Since April 1972 a modified windshield header molding and modified guide bearings have been installed in these vehicles.

## Production Breakpoint

Fig. 1

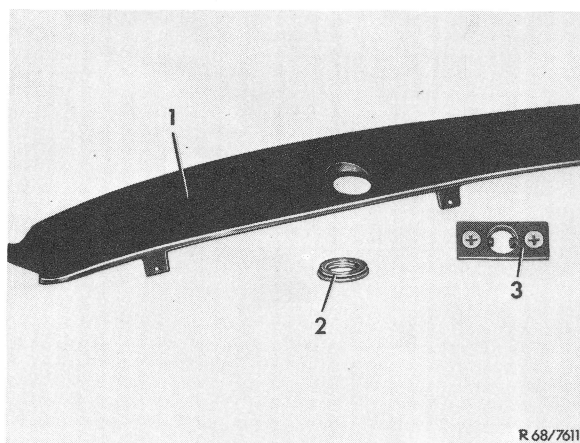
When installing the modified windshield header molding in vehicles with lower chassis end numbers, the two guide bearings and the two washers must also be replaced.

- 3 Install modified guide bearings (3).
- 4 Insert washers (2) into the two bores of windshield header molding (1) (Fig. 1).

Fig. 2

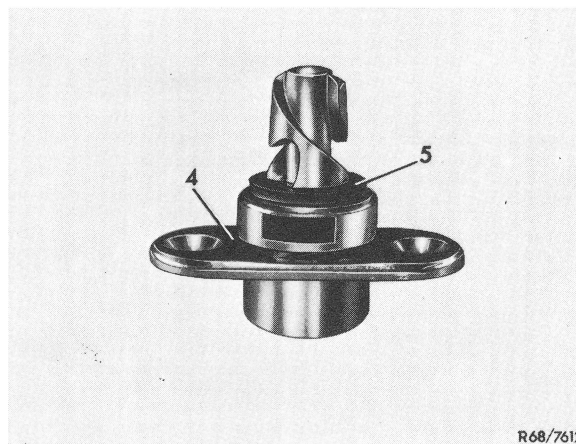
**Note:** The top catch can also be installed in types of model series 113. On these vehicles, however, each catch should be fitted with an additional plastic washer Part No. 111 776 80 97.
